Clinton Power Station, Unit 1  
Facility Operating License No. NPF-62  
NRC Docket No. 50-461

**Subject:** Additional Information Supporting the Request for License Amendment Related to Onsite Spent Fuel Storage Expansion

### Additional Information Supporting the Request for License Amendment Related to Onsite Spent Fuel Storage Expansion

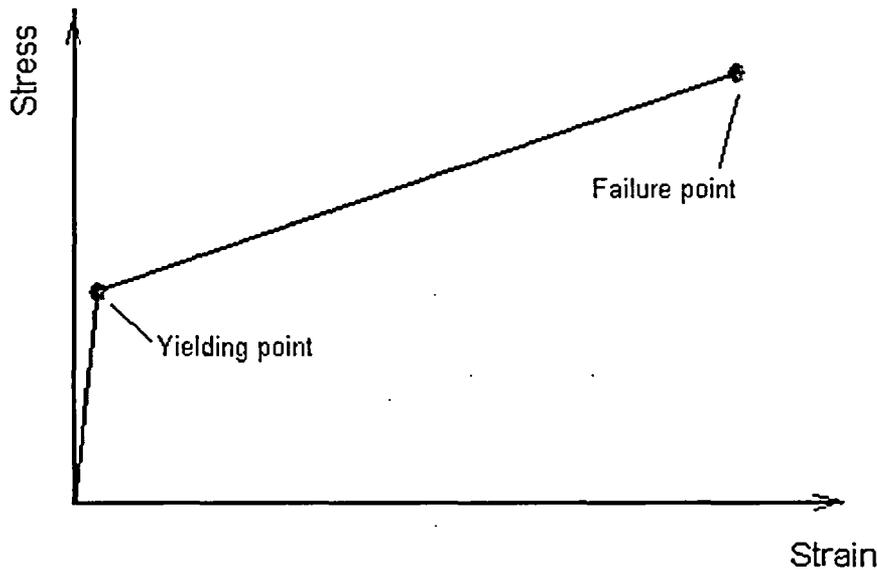
*With respect to Sections 7.3, 7.4 and 7.5 of Attachment 5, briefly discuss key assumptions and engineering modeling approaches utilized in obtaining the results summarized in Section 7.5, and confirm if the engineering reliability associated with these reported analytical results was reasonably verified and documented via some experimental work.*

The model for deep drop, scenario 2, emphasizes the structural responses of the rack pedestal, the bearing pad, the SFP pool liner and the underlying concrete slab. Since the impact takes place directly above a rack support pedestal, the rack cells are assumed to be safe in this scenario and are not modeled for numerical efficiency. Therefore, the rack is represented only by a pedestal cylinder and the mating female block, as well as a portion of the rack base plate with mass density adjusted to match 1/4 of the total weight of the smallest empty rack. The model also includes the bearing pad, the stainless steel liner, and the concrete slab resting on subgrade. The concrete slab model is fixed at the bottom surface and restrained from moving in the horizontal directions at the periphery to simulate the confining effect by surrounding concrete. Finally, the fuel assembly is represented by a rigid fuel assembly end fitting modeled with the full dropped weight.

The following key assumptions are also employed in the various drop analyses.

FIGURE 1

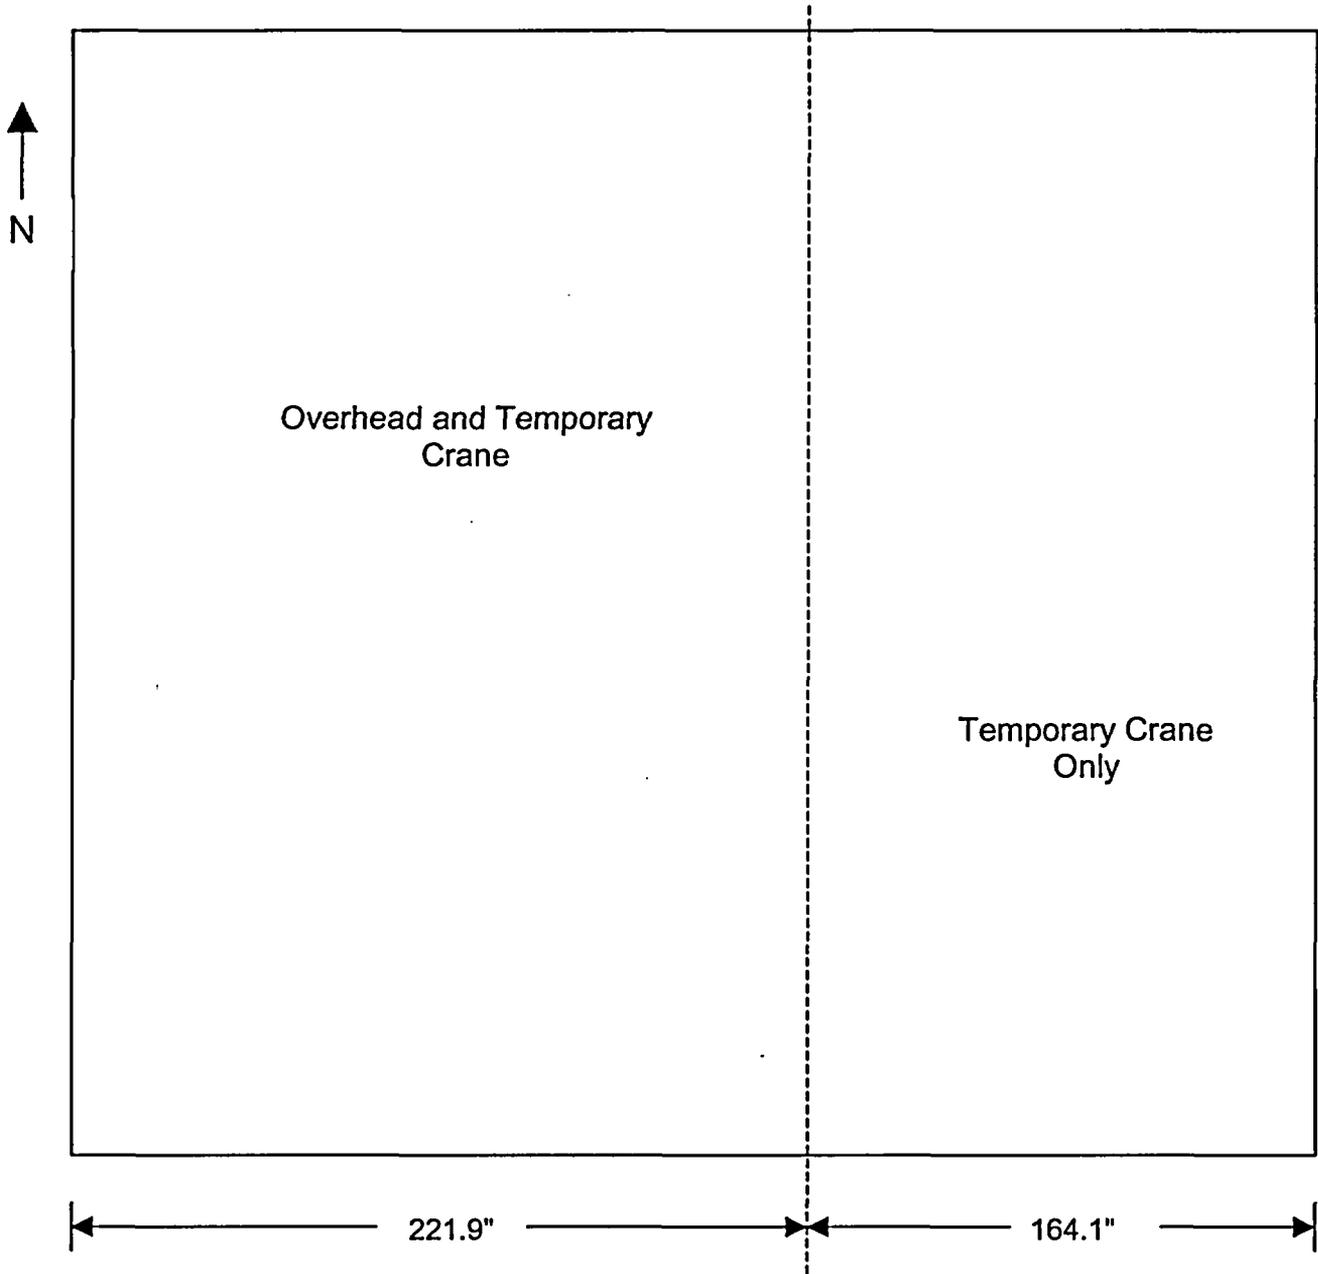
*Please provide a plan view of CPS' SFP and fuel cask storage pool with indication of areas to be covered by the fuel building crane and the low profile temporary crane operations, respectively, with a description of applicable administrative controls to be imposed on operations. Also, as applicable, please provide a discussion of design considerations for temporary platforms which may be used to support the CPS' spent fuel re-racking operation including a description of how they will be supported and connected to the pool and duration of using the platforms.*

Figure 1 provides a schematic showing the travel limit restrictions of the overhead crane with respect to the SFP. New and existing racks that are on the West (i.e., left) side of the line indicated on the figure can be removed or installed with the existing building overhead crane. A temporary crane will be constructed and installed on the fuel handling platform rails to gain access to the affected racks. The temporary crane will be configured such that it may also be used to handle all of the racks in the pool. Though the overhead crane remains an option for handling the accessible existing and new racks, it will be considered a back-up system to the newly reconfigured full height temporary crane. The design of the temporary crane includes personnel platforms supported by the end trucks of the crane. These platforms will move along with the crane and will only be in place while the temporary crane is in place on the fuel handling platform rails.

The temporary crane will have access to install racks in the cask and spent fuel pools. The Clinton overhead crane will have access to install racks in the cask pit and a majority of the spent fuel pool as shown above.
